FlexPLI weight tolerances

Reduction of proposed weight tolerances

International Organization of Motor Vehicle Manufacturers (OICA)

Pedestrian Protection

Assessment of the weight of available FlexPLI's

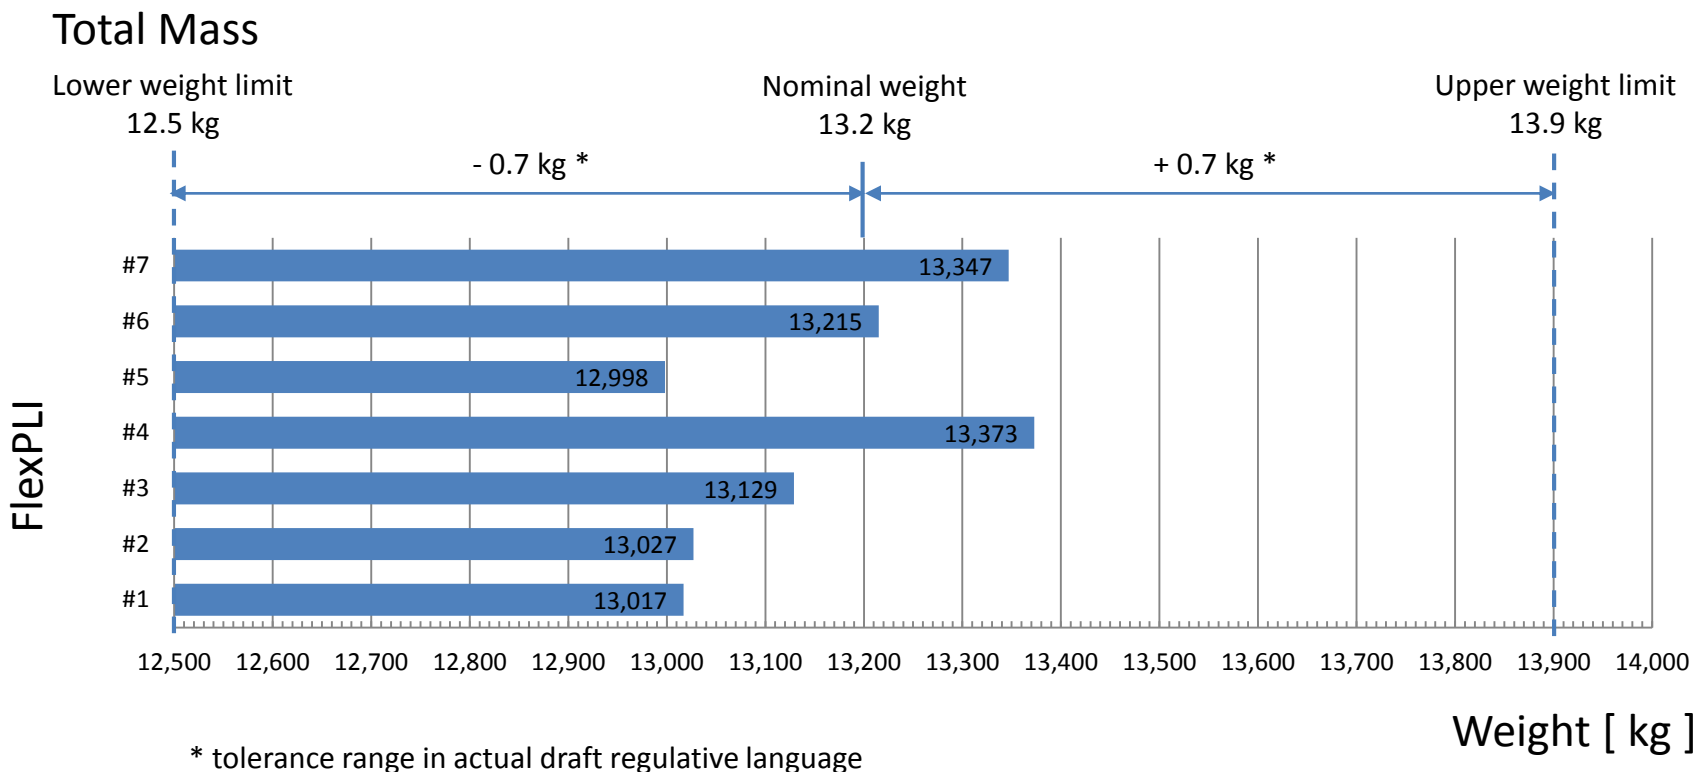
target weight GTR9	FlexPLI							mean values	max deviation
		#1	#2	#3	#4	#5	#6	#7		
total weight of FlexPLI in testing order	13.2	13.017	13.027	13.129	13.373	12.998	13.215	13.347	13.139	0.375
Assembled mass of the femur, the knee joint and the tibia, without the flesh and skin	9.38	9.207	9.242	9.219	9.522	9.24	9.445	9.520	9.298	0.315
total weight of neoprene covers (N1F + N1T + N2F + N2T + N3)		0.979	0.970	0.932	1.051	0.967	0.991	0.946	0.980	0.119
total weight of rubber sheets (R1+R2)		2.780	2.764	2.915	2.8	2.745	2.730	2.833	2.801	0.151

Assembled mass of femur, knee joint and the tibia, without flesh and skin

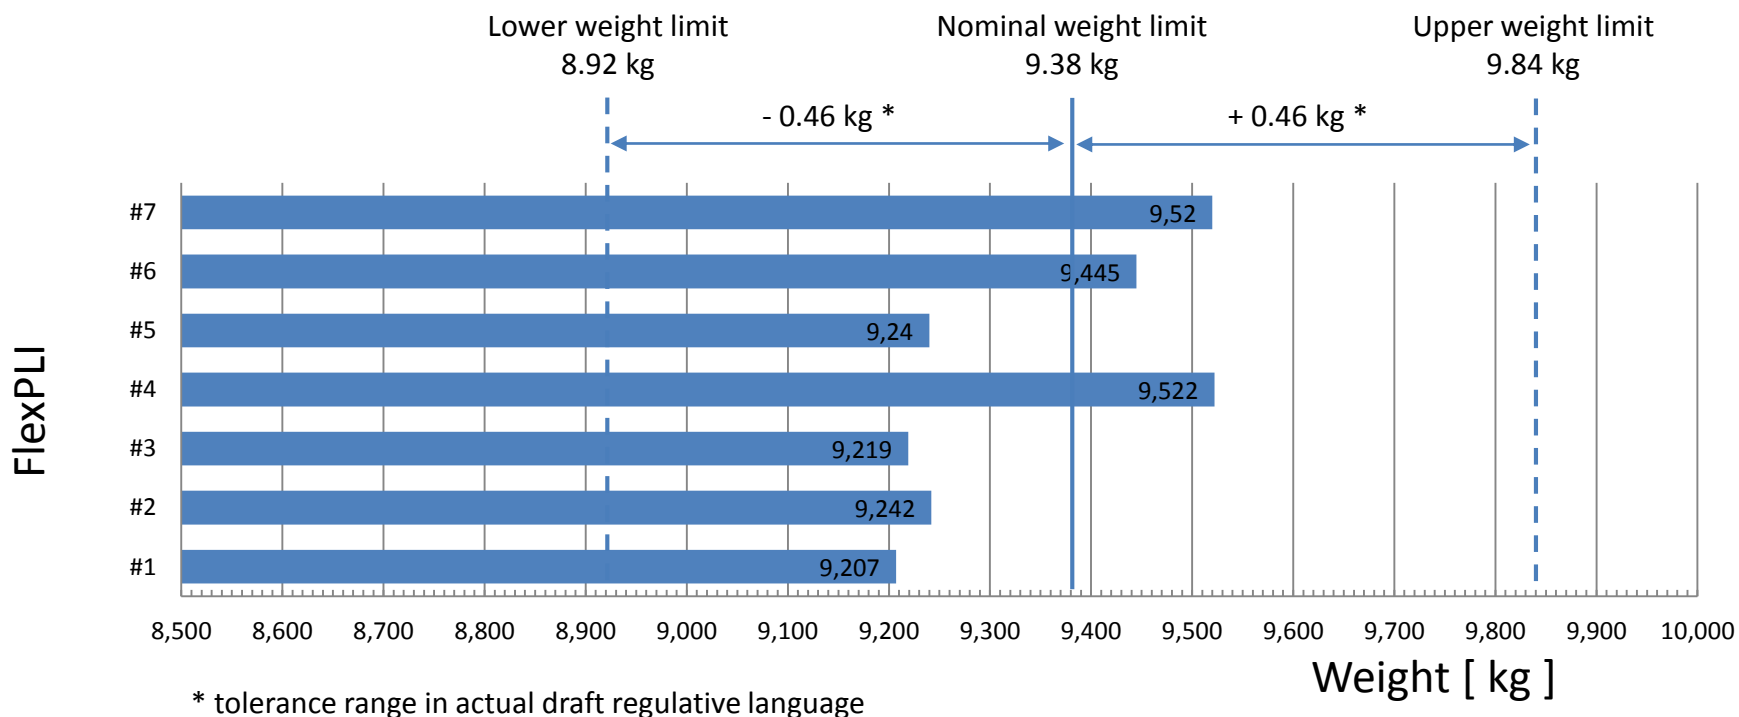
Assessment of the weight of available FlexPLI's

Figure 12
of doc.
UNECE/TRANS/WP.29/GRSP/2013/25

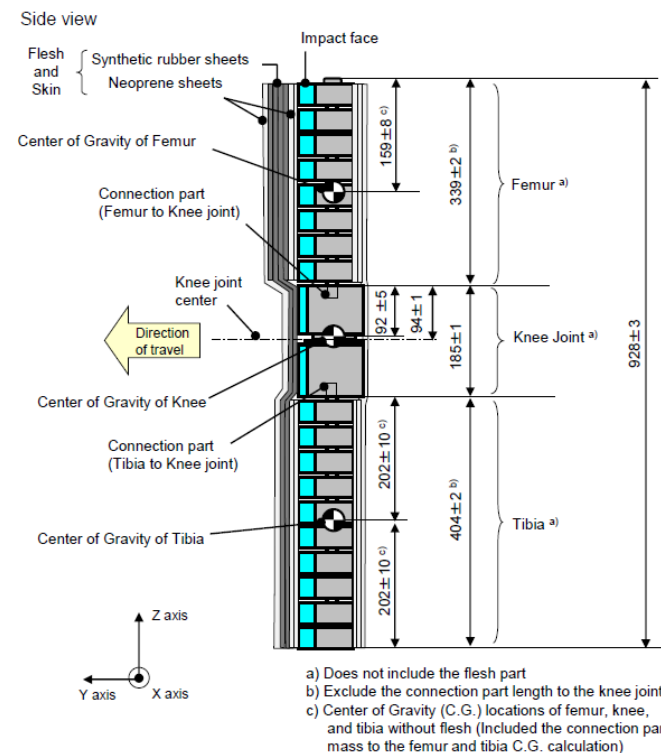
- Unchanged tolerances for femur, tibia and knee subassemblies (position of center of gravity of FlexPLI)

Total Mass

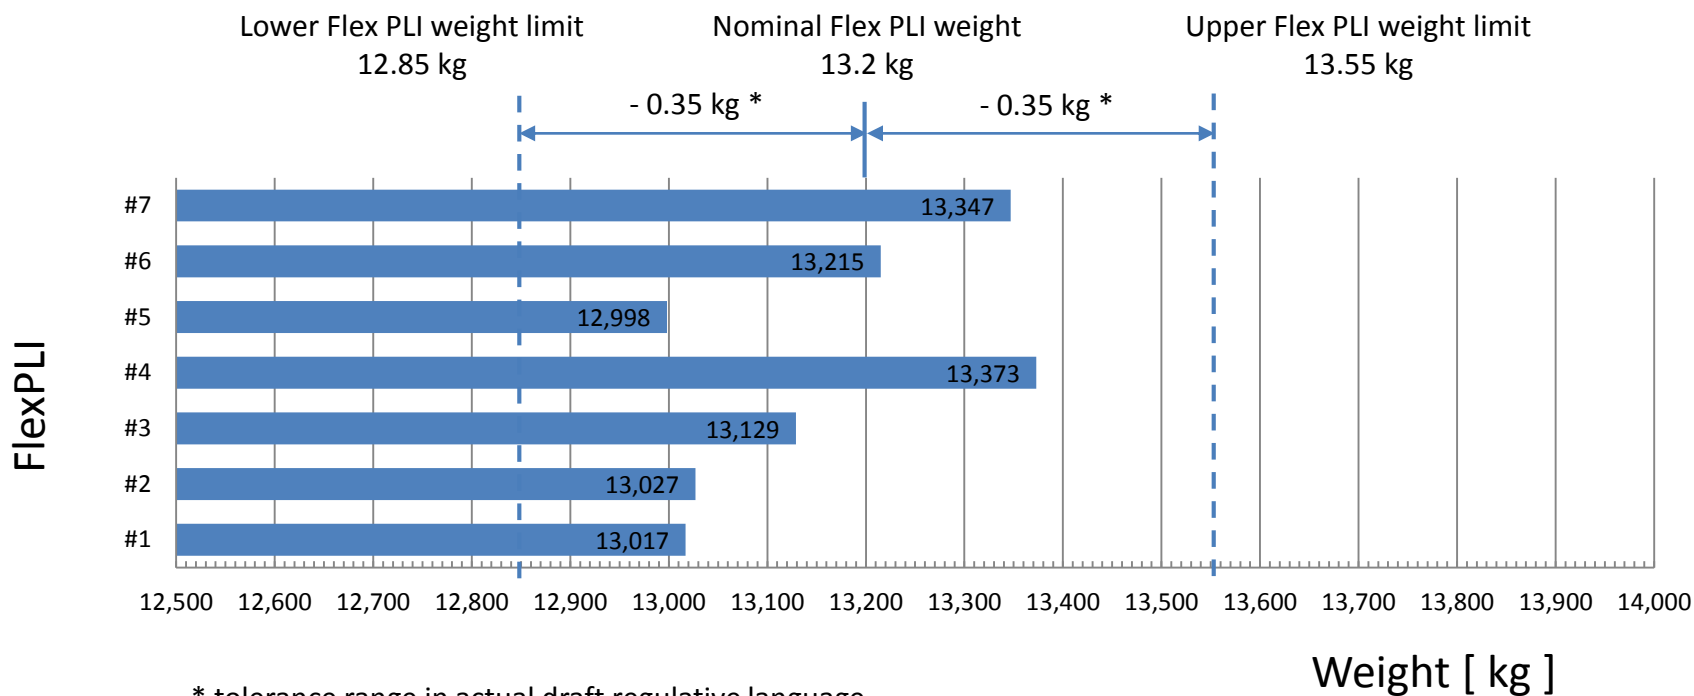
Proposal for reduced FlexPLI weight tolerances

- Weight tolerance of ± 0.35 kg for total FlexPLI
- Weight tolerance of ± 0.23 kg for assembled mass of femur, the knee joint and the tibia without the flesh and skin

Assembled mass of femur, knee joint and the tibia, without flesh and skin

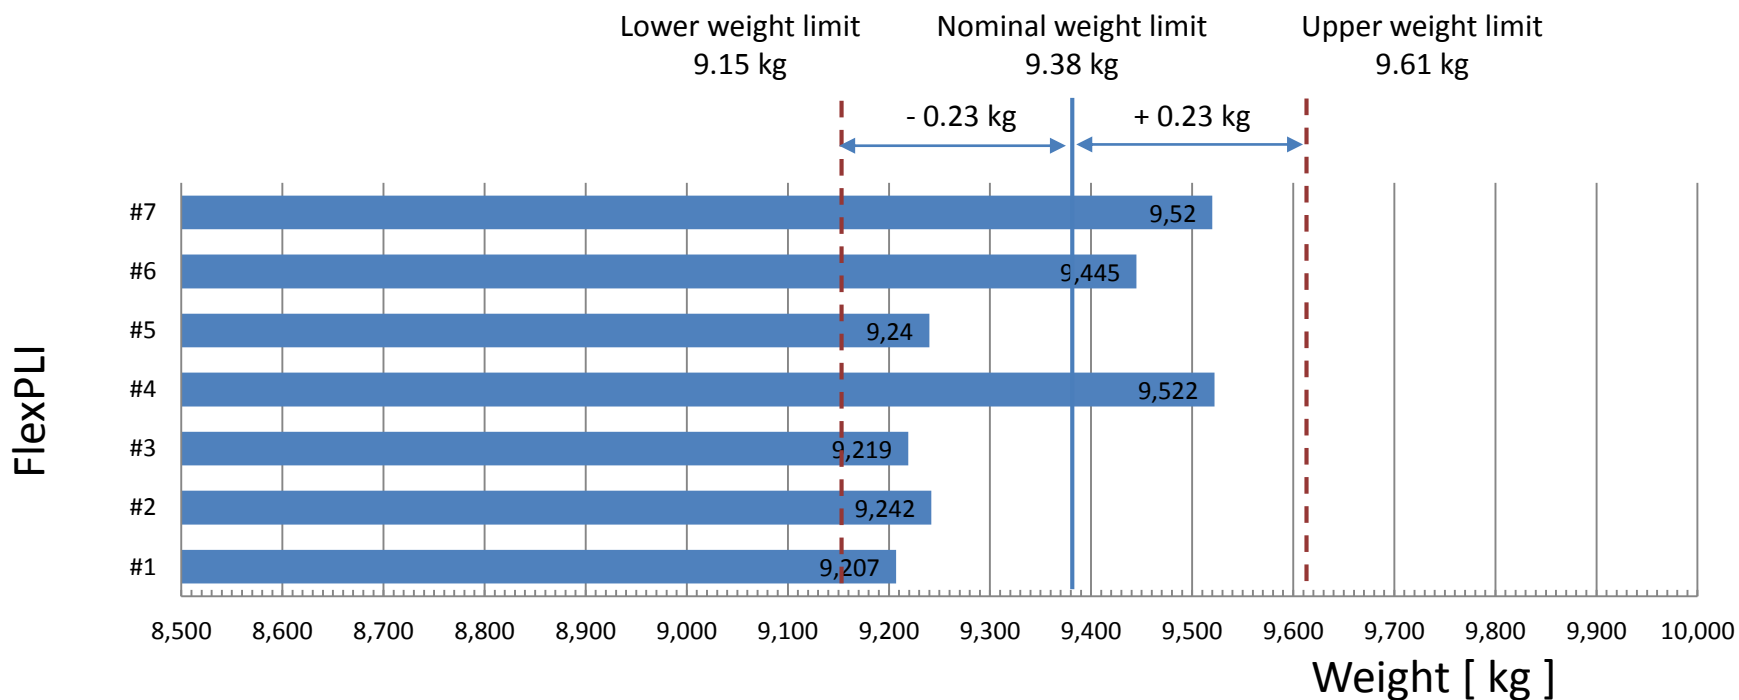
Proposal for reduced FlexPLI weight tolerances
